SHOWGROUND PRECINCT EAST

BUILDING A, B & C

SSD 62802207 MOD Proposed Facade Changes- Comparison Schedule

PROPOSED FACADE DEVELOPMENT

BUILDING A- ELEVATION COMPARISON

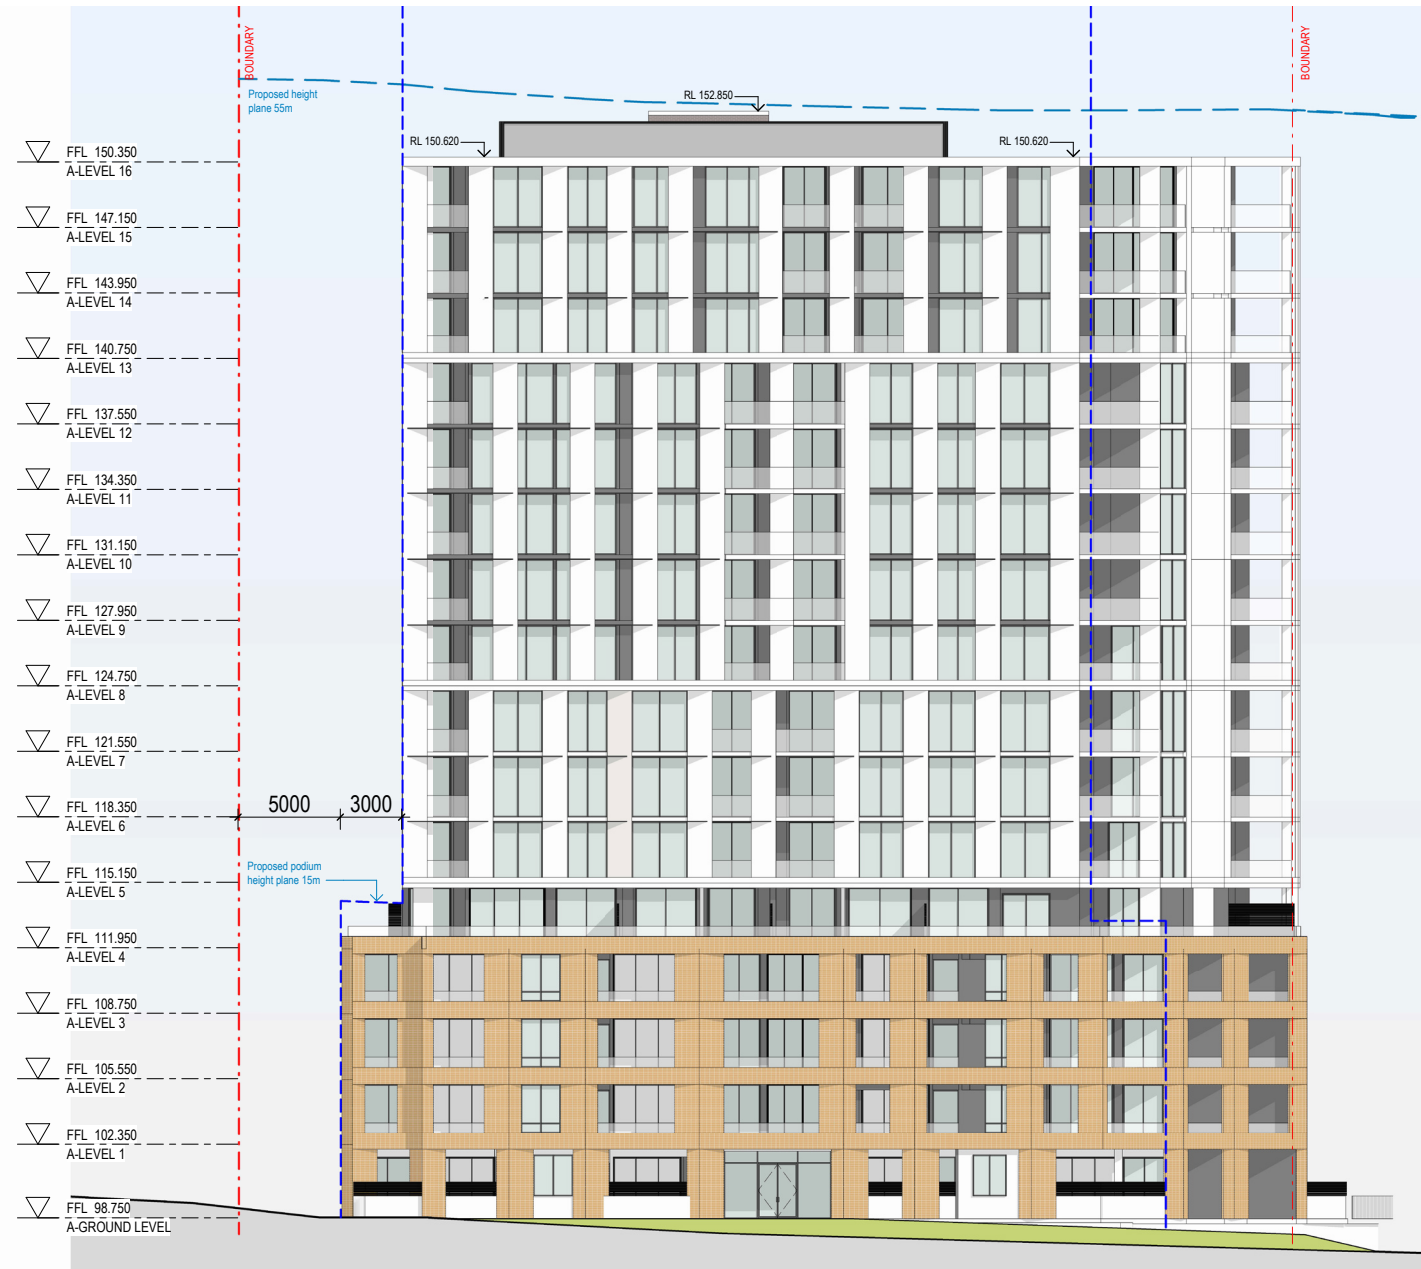
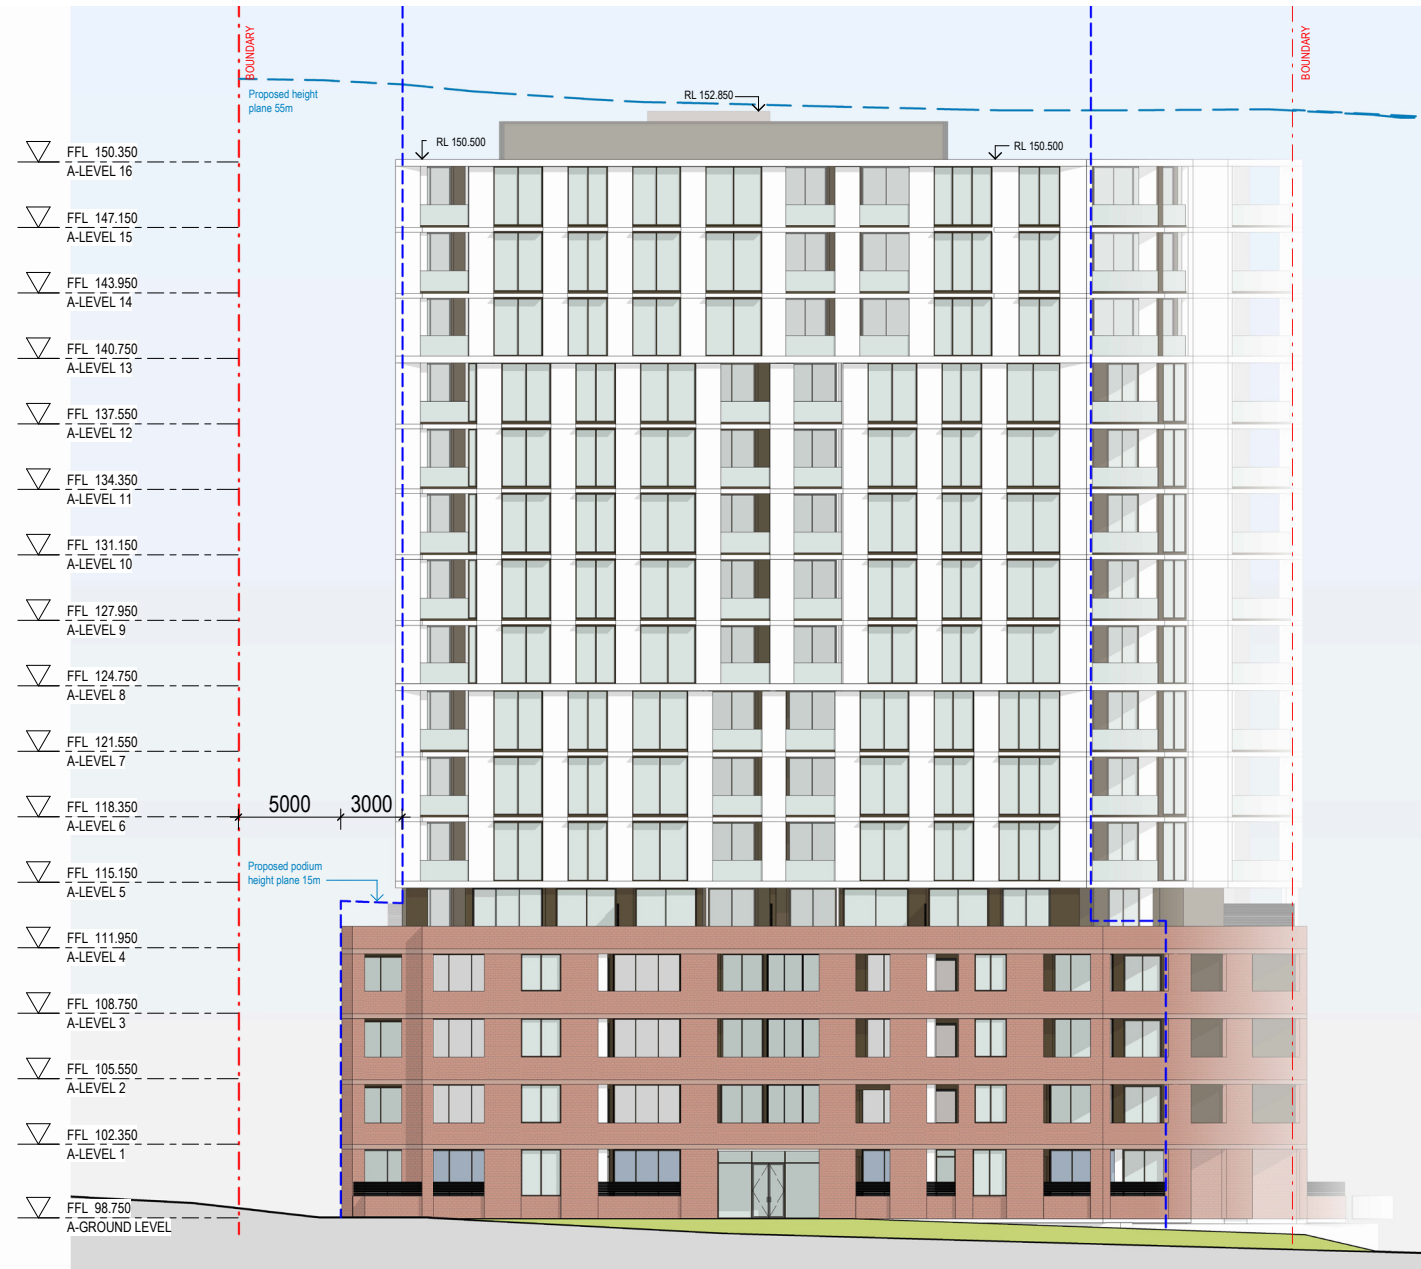
- A. Replaced applied tiles at podium levels with brickwork
- B. Exposed painted slab to podium level
- C. Replaced metal cladding/ brick panels to FC cladding to all tower facade
- D. Rationalised balustrades type to either full glass balustrade or full solid balustrade
- E. Adjustment to screens
- F. Lift and stair core walls changed to rendered and painted finish
- G. Upgrade windows at level 1-3 in Building C to full height glazing
- H. Remove roof frame
- N. Remove splay edges in Building A facade

SSD 62802207 Approved Facade Changes
North Elevation

Proposed Facade Changes:
North Elevation

BUILDING A- ELEVATION COMPARISON

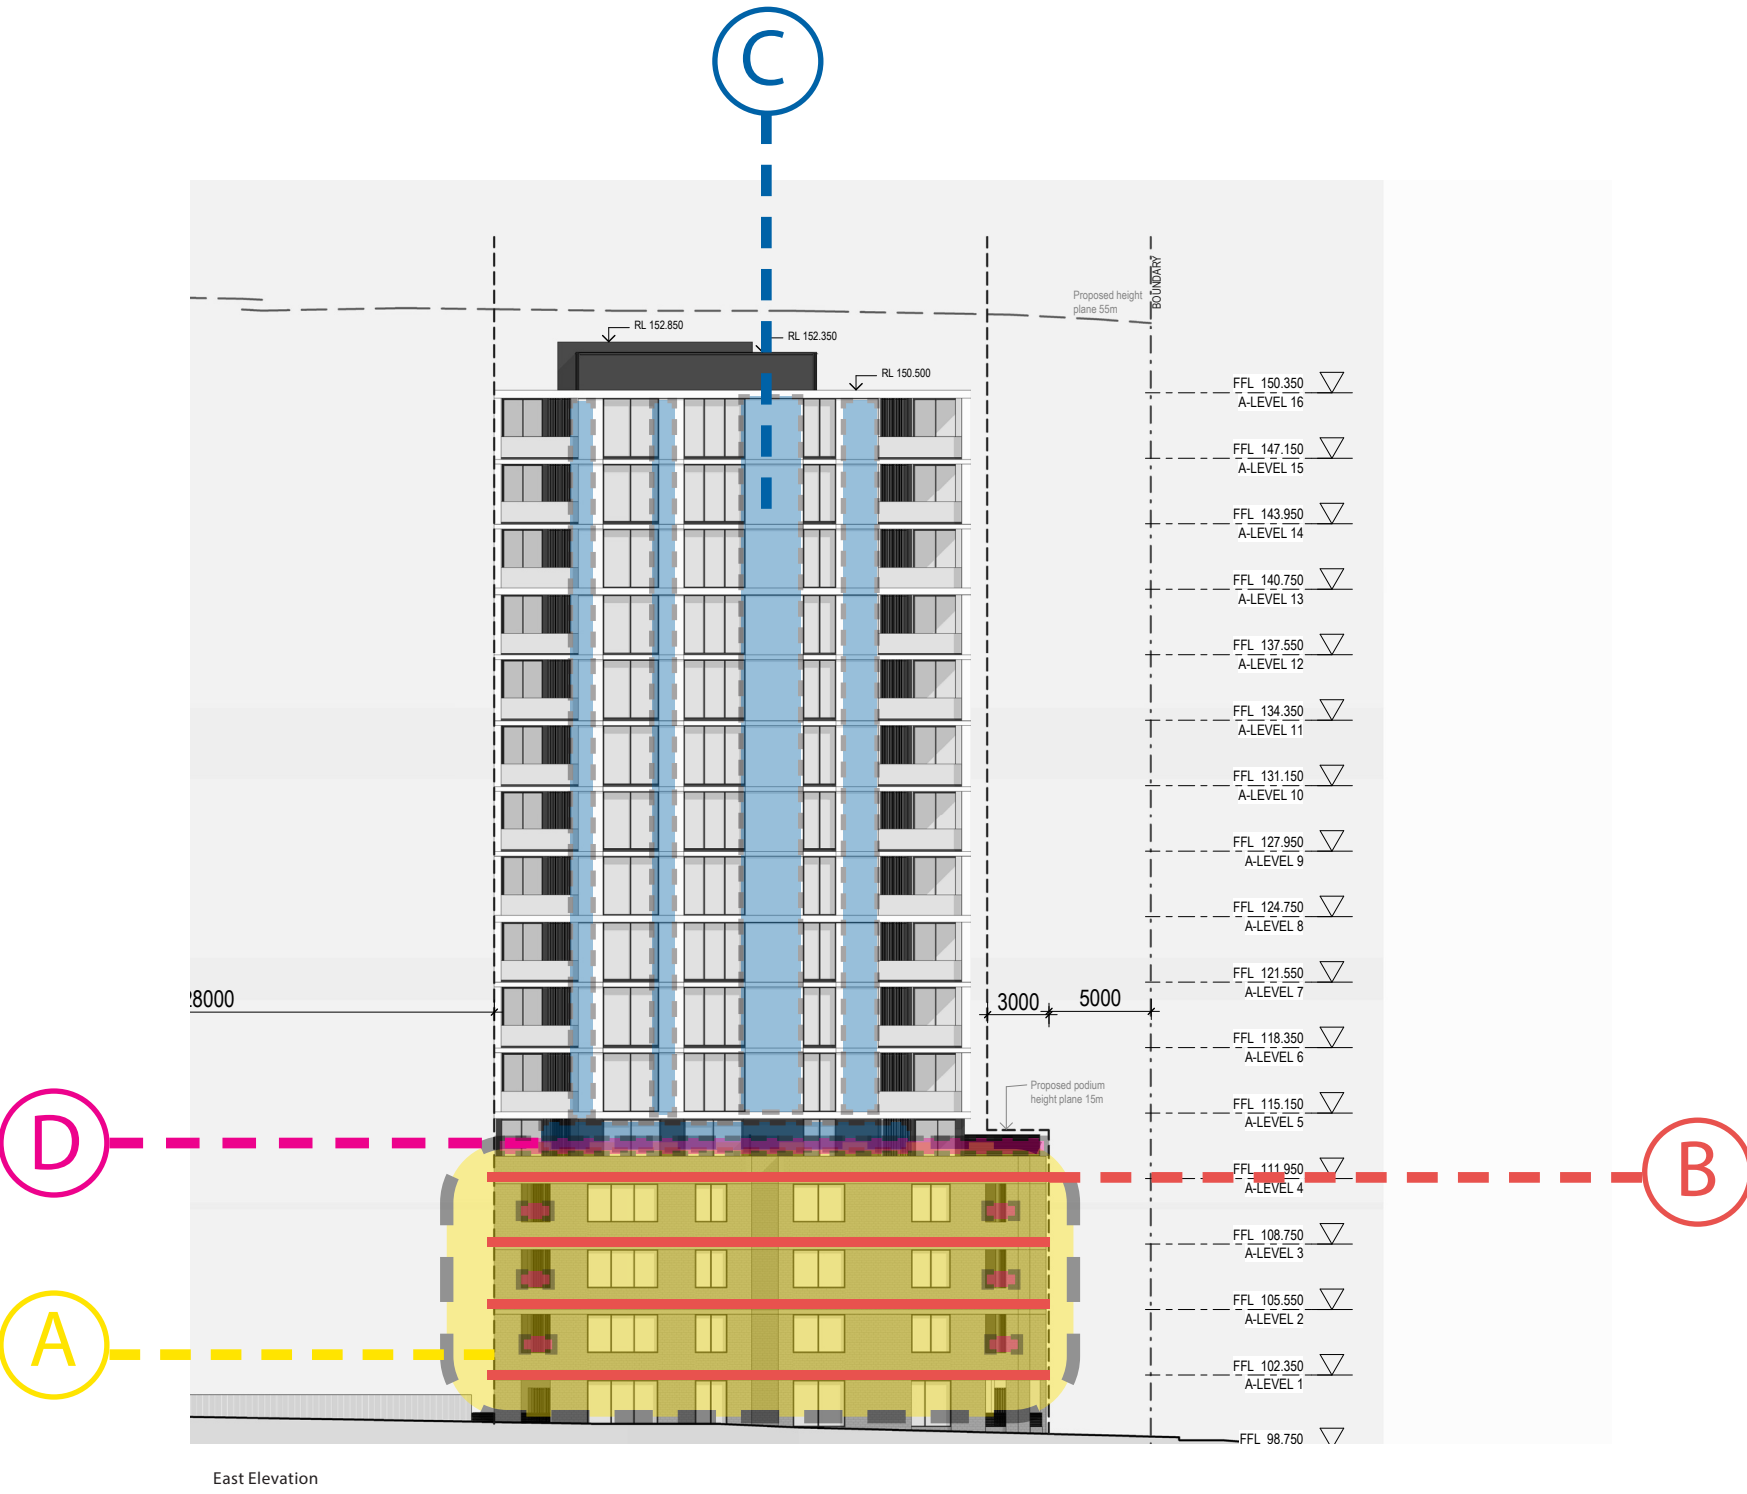
- A. Replaced applied tiles at podium levels with brickwork
- B. Exposed painted slab to podium level
- C. Replaced metal cladding/ brick panels to FC cladding to all tower facade
- D. Rationalised balustrades type to either full glass balustrade or full solid balustrade
- E. Adjustment to screens
- F. Lift and stair core walls changed to rendered and painted finish
- G. Upgrade windows at level 1-3 in Building C to full height glazing
- H. Remove roof frame
- N. Remove splay edges in Building A facade

SSD 62802207 Approved Facade Changes
South Elevation

Proposed Facade Changes:
South Elevation

BUILDING A- ELEVATION COMPARISON

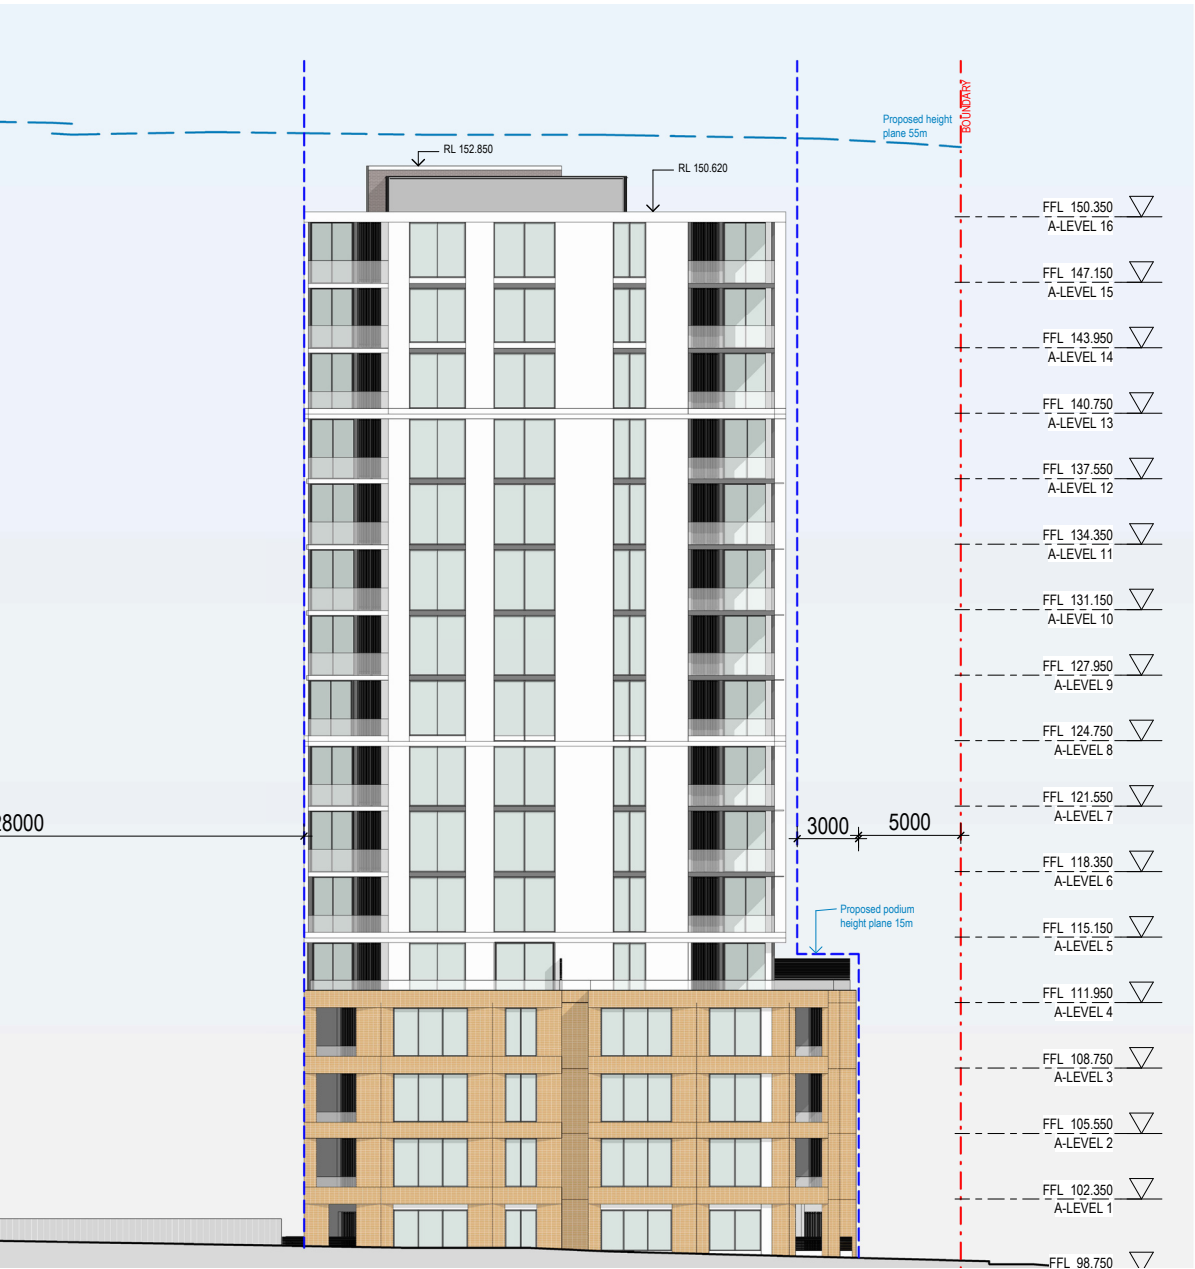
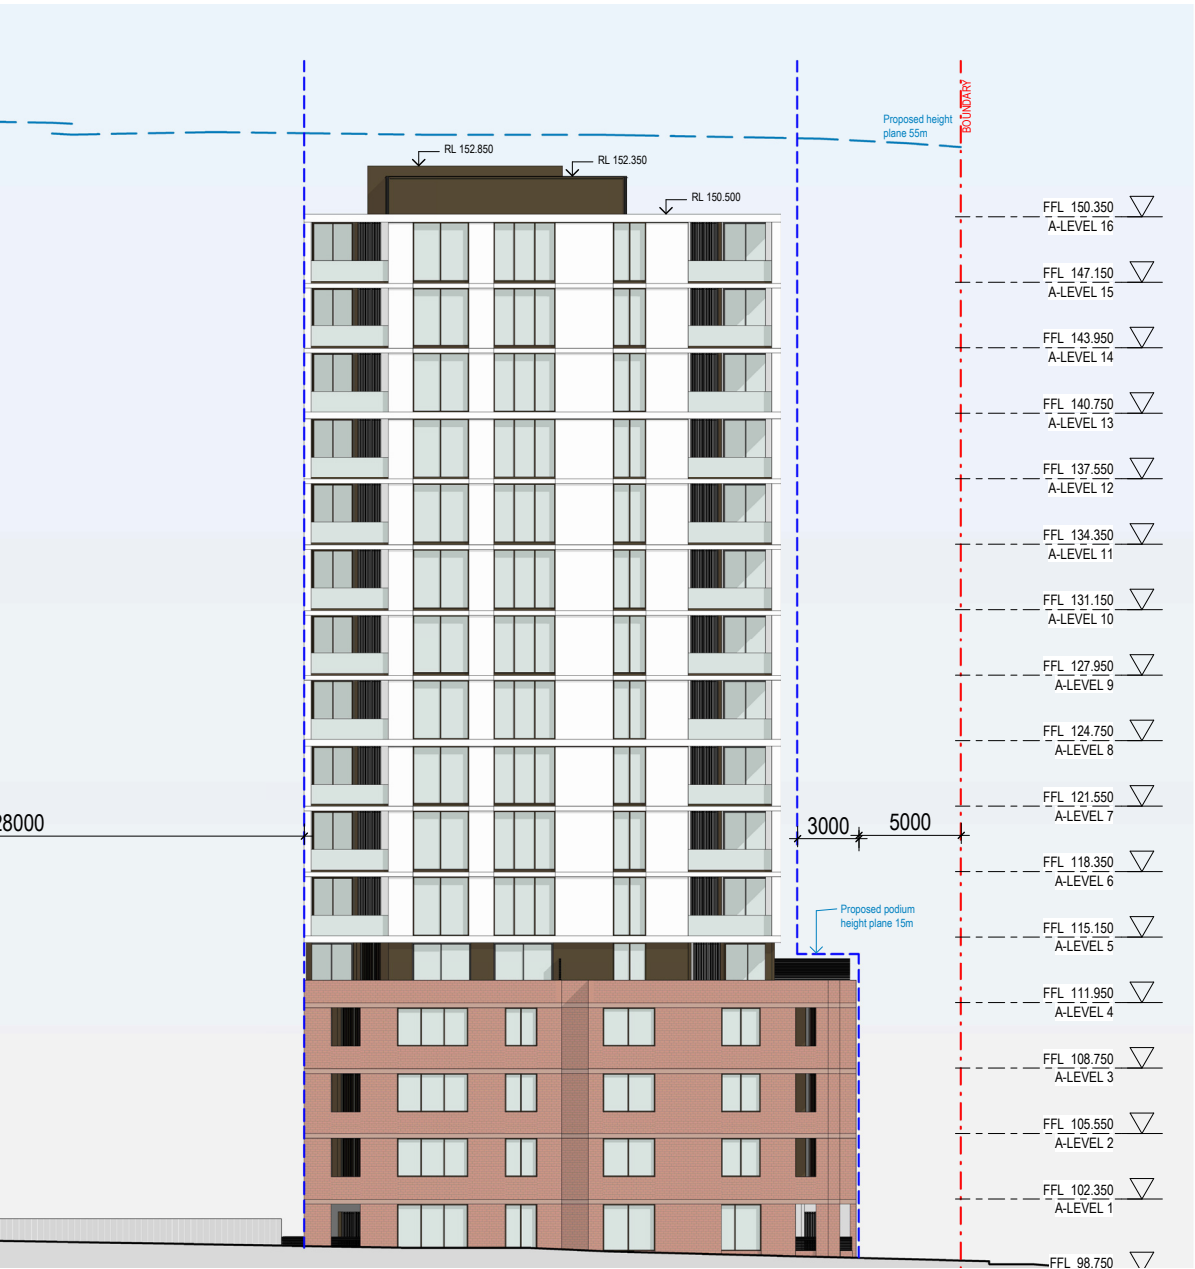
- A. Replaced applied tiles at podium levels with brickwork
- B. Exposed painted slab to podium level
- C. Replaced metal cladding/ brick panels to FC cladding to all tower facade
- D. Rationalised balustrades type to either full glass balustrade or full solid balustrade
- E. Adjustment to screens
- F. Lift and stair core walls changed to rendered and painted finish
- G. Upgrade windows at level 1-3 in Building C to full height glazing
- H. Remove roof frame
- N. Remove splay edges in Building A facade

SSD 62802207 Approved Facade Changes
East Elevation

Proposed Facade Changes:
East Elevation
